UNITED KINGDOM HOLOCAUST MEMORIAL & LEARNING CENTRE

Design and Access Statement
January 2026 Addendum

2.1 MINOR EXTERNAL CHANGES 2026

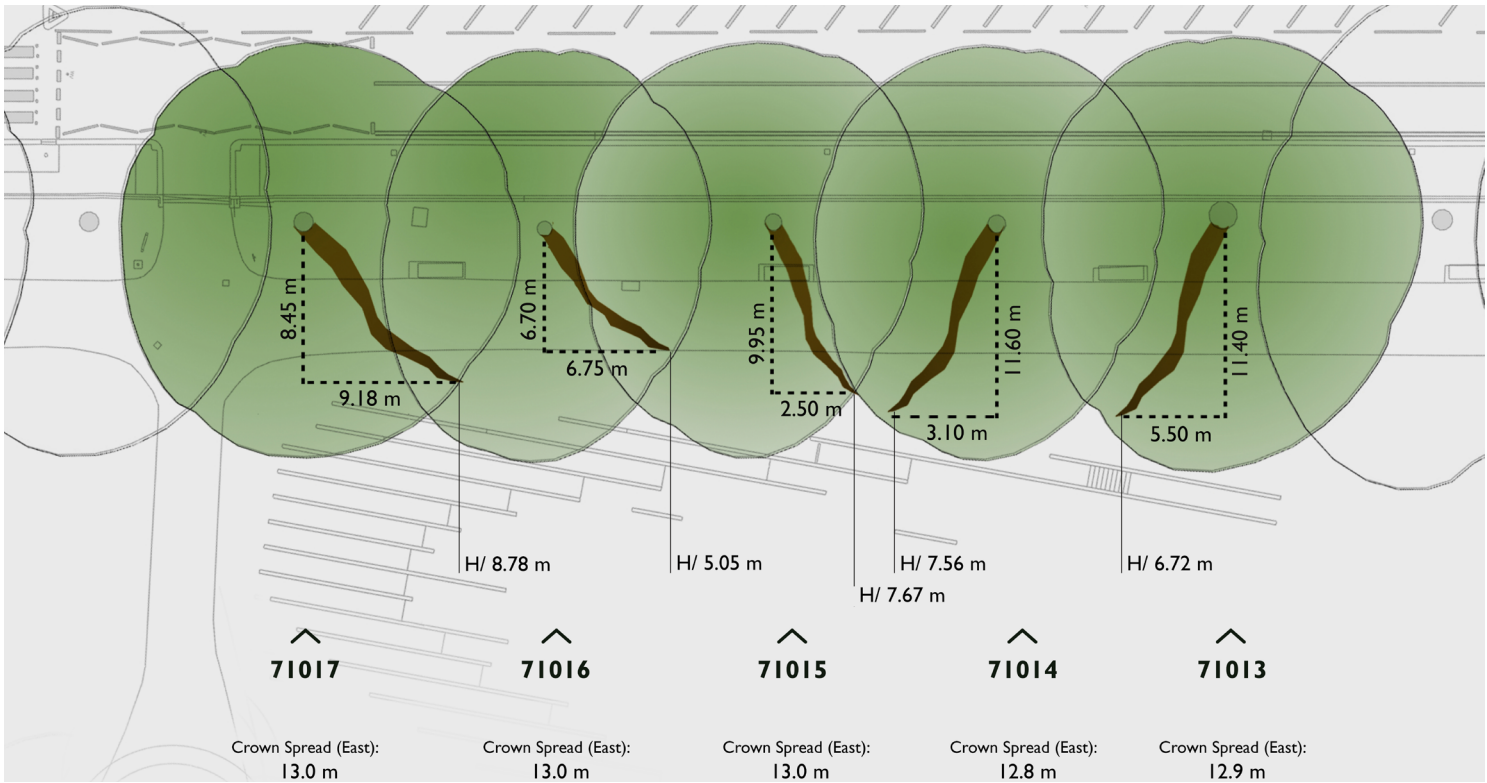
- Memorial courtyard minor gradient change.
- Memorial bronze fins within the memorial courtyard have 200mm additional plinth area.
- Memorial entrance stairs 3 steps removed to comply with building regulations.

External Appearance

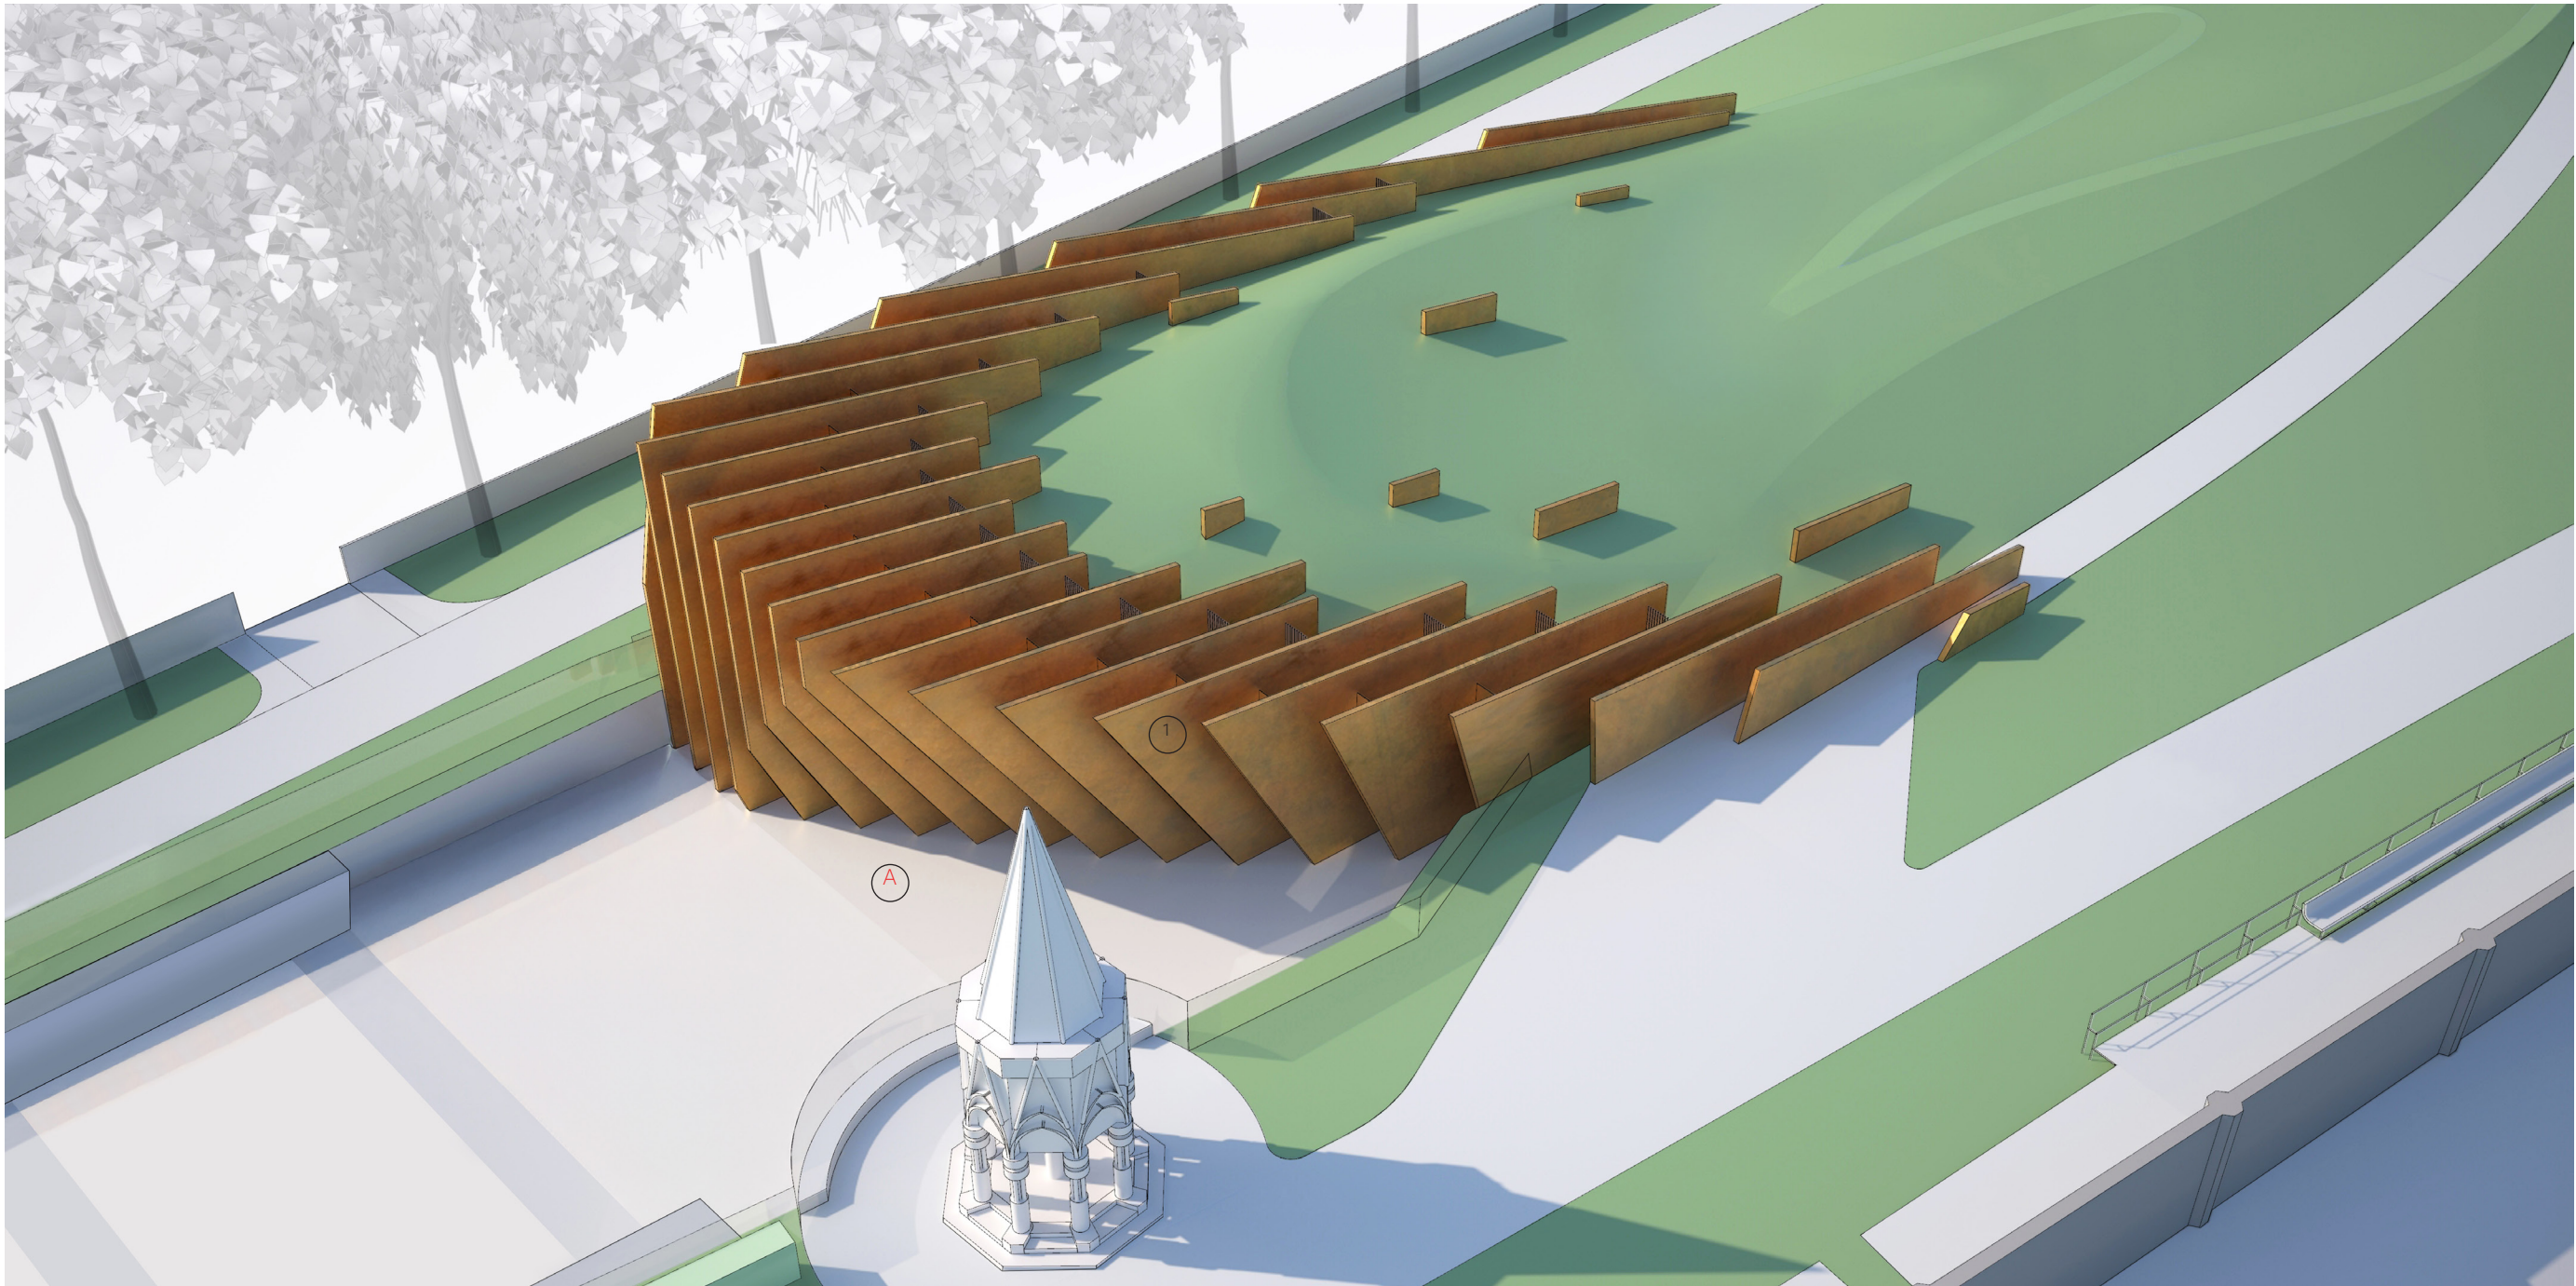
The memorial courtyard level (B1) has been lowered by 200mm, and the basement level (B3) raised by 310mm - see annotations A and B. These coordinated level adjustments have been undertaken to ensure full compliance with current Building Regulations, while also improving accessibility and circulation through the memorial. The changes affect the levels at the base of the memorial fins only, resulting in a marginal increase in the visible height of the bronze fins at courtyard level and a corresponding marginal reduction at basement level, without any change to their number, position or overall height.

- A B1 Level lowered by 200mm
- 1 23 No. Memorial Fins - No change to number, position, or overall height

Access Strategy

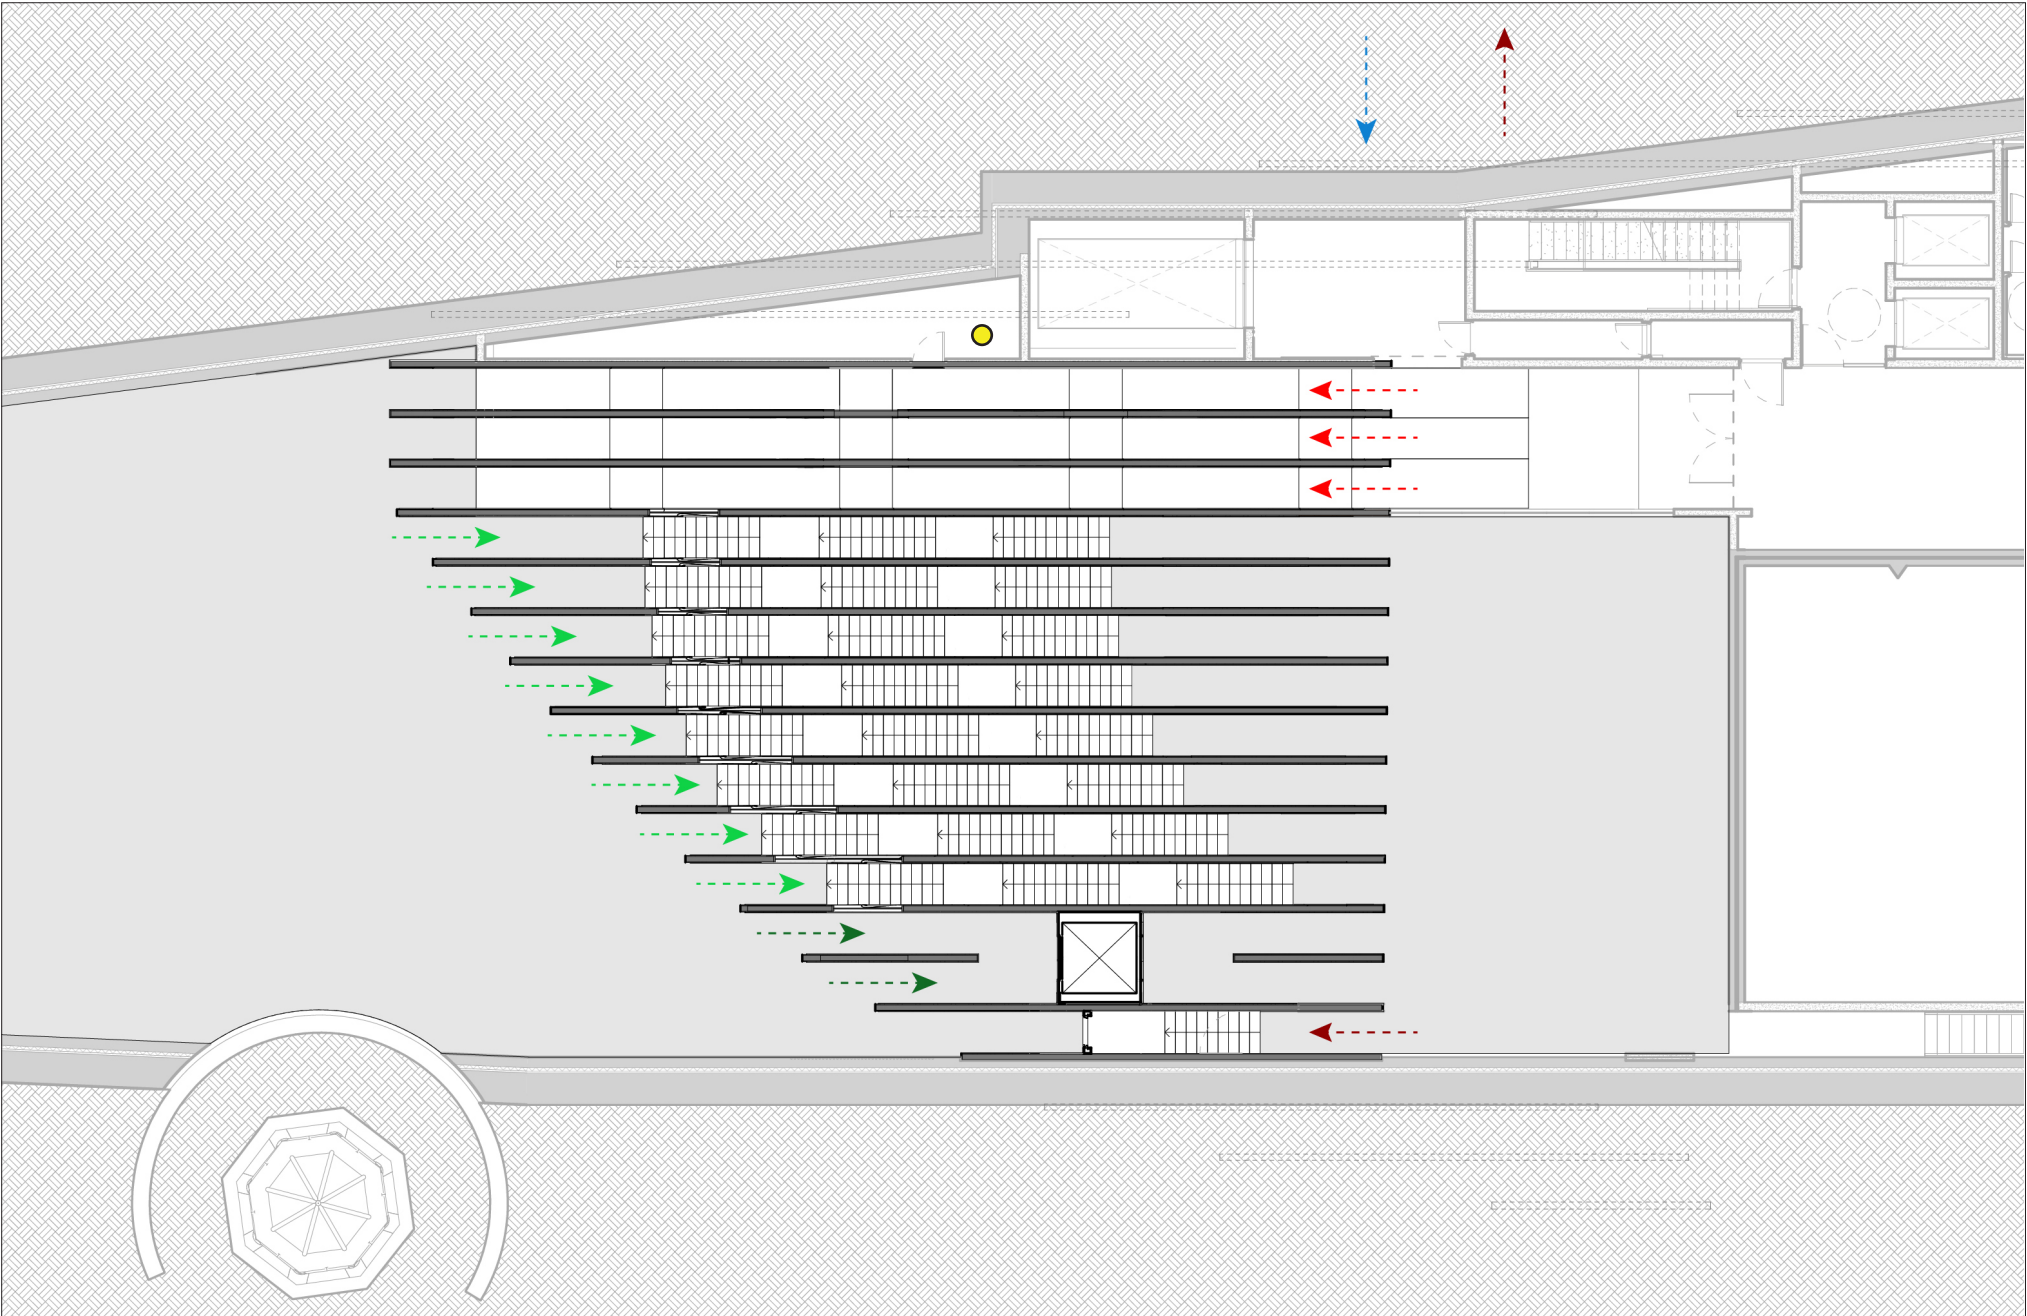
The revised scheme incorporates coordinated level changes to the memorial courtyard and basement, which have informed a series of targeted refinements to circulation, access and associated elements. Key changes include:

- Reduction in stair risers within the eight memorial stairways from 39 to 36 (three flights of 12), in line with Approved Document M
- Minor adjustment at the base of the memorial fins only to suit the revised levels and updated stair and ramp arrangements
- Reconfiguration of memorial exit ramps and landings to achieve ADM-compliant lengths, widths, gradients and landing sizes
- Updated memorial stair nosings to align with the requirements of Parts M and K
- Adjusted memorial lift landing levels to coordinate with the revised floor levels
- Realignment of drainage channels along all memorial pathways to suit the revised levels and circulation geometry
- Relocation of access door to the basement storage room (B2-B23) to align with the revised exit ramp and landing position

Handrail Detailing

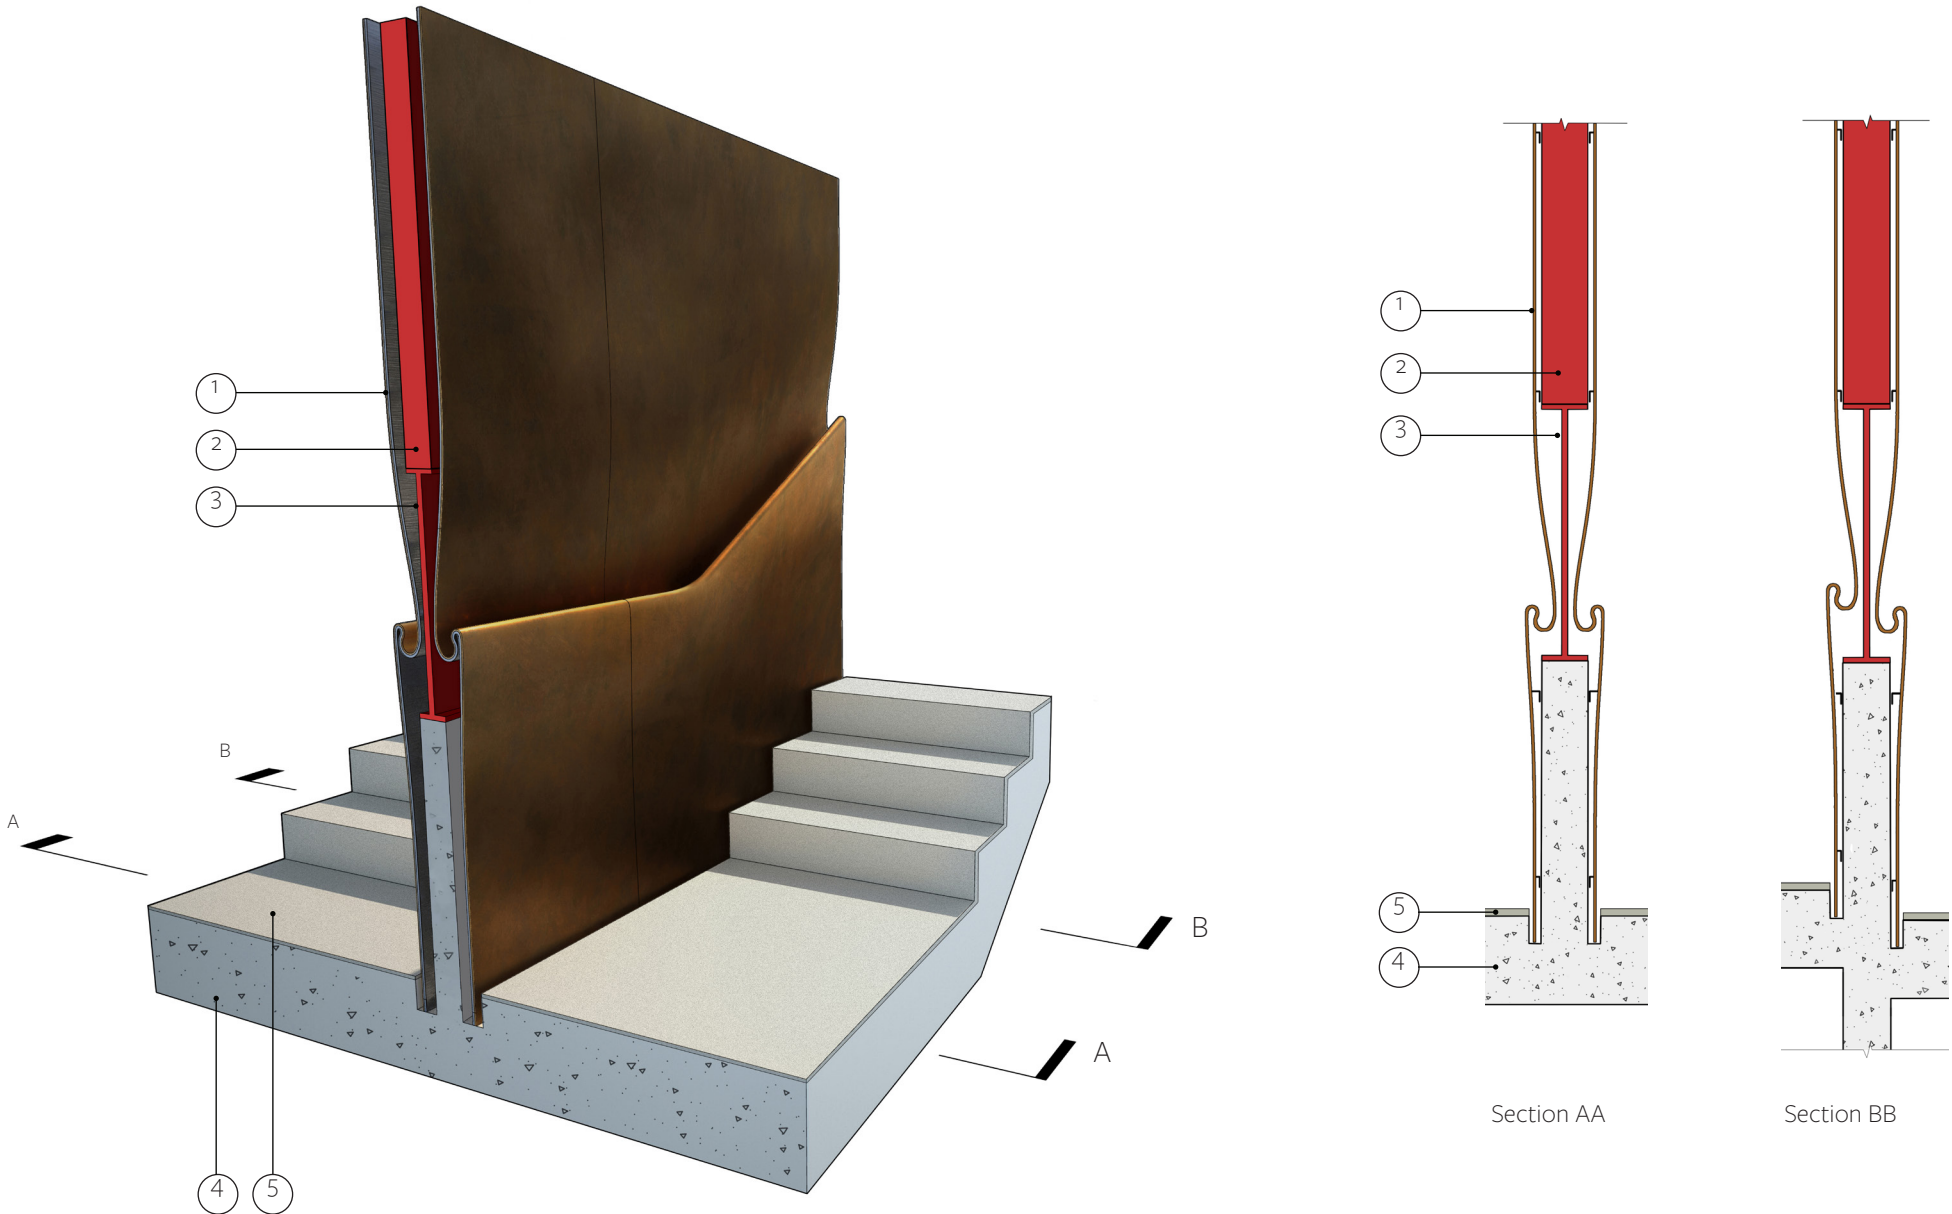
The memorial handrail profile has been refined to ensure full compliance with the functional requirements of Approved Documents K, M and B, together with the guidance set out in BS 8300.

The handrails are conceived as an integrated component of the bronze fin walls, which collectively form a sculptural installation within an architectural context. The fine tuning of the handrail profile will not result in any material change to the design of the memorial.

3.1 DAY VIEW LOOKING NORTH TOWARDS THE MEMORIAL 2026

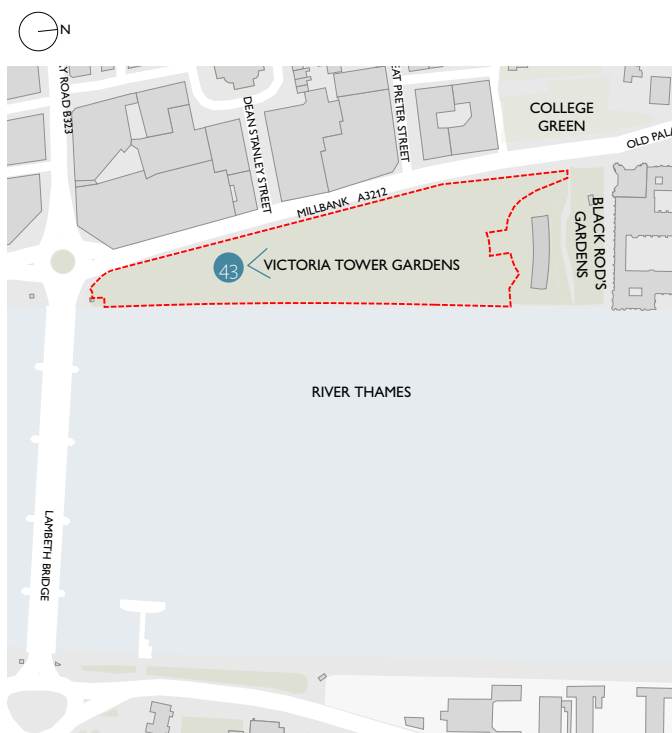
View 43: Victoria Tower Gardens - day
The only minor change due to updated building regulations in this view is the gradient of the memorial courtyard getting fractionally steeper as it moves towards the bronze memorial fins. This only happens within the confines of the courtyard and has not affect on the mass or height. Additional 20cm of bronze will be visible at the base of the memorial fins only.

3.3 NIGHT VIEW LOOKING NORTH TOWARDS THE MEMORIAL 2026

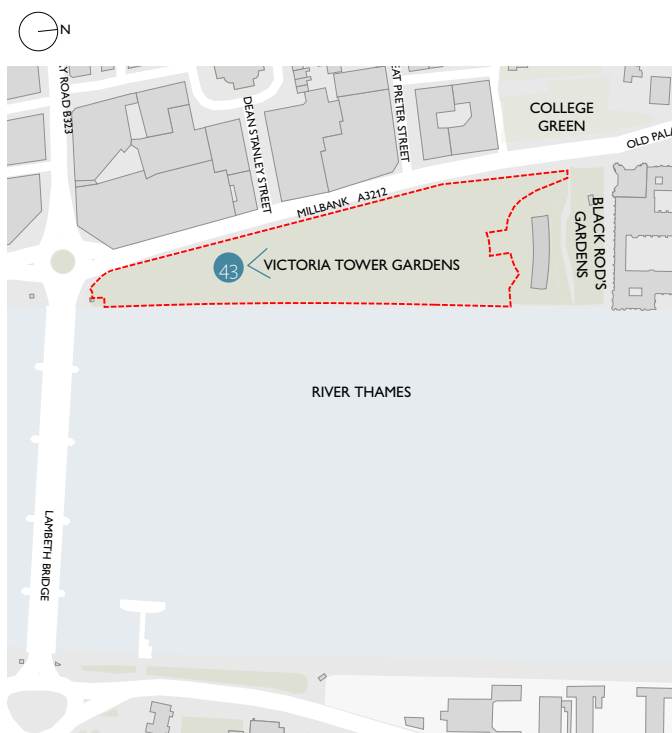
View 43: Victoria Tower Gardens - night
The only minor change due to updated building regulations in this view is the gradient of the memorial courtyard getting fractionally steeper as it moves towards the bronze memorial fins. This only happens within the confines of the courtyard and has not affect on the mass or height. Additional 20cm of bronze will be visible at the base of the memorial fins only.
